<p>CONSERVATION SOLUTIONS inc ART • ARCHITECTURE • ARTIFACTS</p>	
<p>FRENCH GILDED FOUNTAIN ASSESSMENT</p>	
<p>HILLWOOD MUSEUM &amp; GARDENS</p>	
<p>DATE: 5/10/17 DRAWN BY: mjr</p>	
<p><span style="color: magenta;">■</span> MARBLE</p>	
<p><span style="color: gold;">■</span> GILDED LEAD</p>	
<p><span style="color: red;">■</span> BRICK</p>	
<p><span style="color: blue;">■</span> TILE</p>

ELEVATION

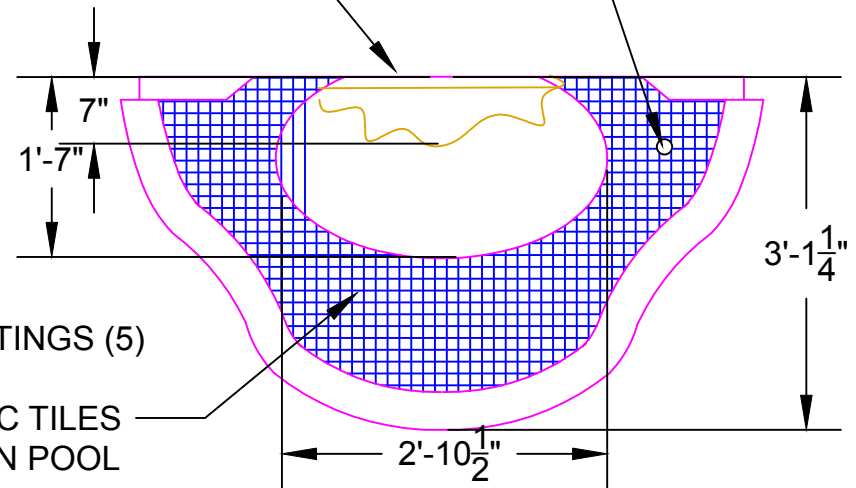
GILDING FAILED 100%  
ON SCULPTURE

DEFORMATION

OPEN JOINT

EROSION & LOSS

CRACK

BLACK STAINING & CRUST

YELLOW STAINS & SCALE

BIOLOGICAL GROWTH  
THROUGHOUT  
BASIN, STAND & COPING
